Access Compliance Report

Public Rights-of-Way

(Curb Ramps)

Intersection ID: 10752	Main Street: W_TRADE_ST	Cross Street: N_BRUNS_AV	Location: S
ADA ID: FFD28D75BC6A	Ramp Type: Perp	Initial Pass/Fail: Fail	Overall Compliance: No
Severity Score: 10			
Codes/Mitigation Info/Possible Solution		Field Measurements/Component Compliance

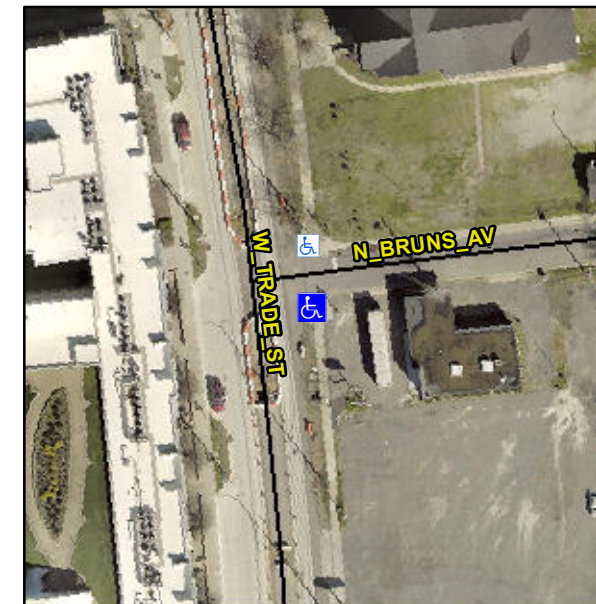
PROW/ADA:

Not Found, R304.5.1, R304.5.3

Compliance	Description	Data	Compliance	Description	Data
N/A	Ramp Length (in)	59.9	Yes	Ramp Slope (%)	6.8
No	Ramp Width (in)	46.0	No	Ramp XSlope (%)	3.8
N/A	Flare Type LT	N/A	N/A	Flare Type RT	N/A
N/A	Flare Slope LT (%)	N/A	N/A	Flare Slope RT (%)	N/A
N/A	Flare Traversable LT?	N/A	N/A	Flare Traversable RT?	N/A
N/A	Landing Length (in)	N/A	N/A	DWS Provided?	N/A
N/A	Landing Width (in)	N/A	N/A	DWS Contrast?	N/A
N/A	Landing Slope (%)	N/A	N/A	DWS Length (in)	N/A
N/A	Landing X Slope (%)	N/A	N/A	DWS Full Width?	N/A
N/A	Landing Curb? (Y/N)	N/A	N/A	DWS Offset (in)	N/A
N/A	Shared Landing?	N/A			
N/A	Gutter Ponding?	N/A	N/A	Gutter Slope (%)	N/A
N/A	Gutter Lip Ht (in)	N/A	N/A	Gutter X Slope (%)	N/A
N/A	Painted X Walk1?	No	N/A	Painted X Walk2?	N/A
	X Walk 1 Direction	To N		X Walk 2 Direction	N/A
N/A	X Walk 1 Width (in)	N/A	N/A	X Walk 2 Width (in)	N/A
	X Walk 1 Slope (%)	5.6		X Walk 2 Slope (%)	N/A
	X Walk 1 X Slope (%)	0.3		X Walk 2 X Slope (%)	N/A

Remove & Replace Entire Ramp.
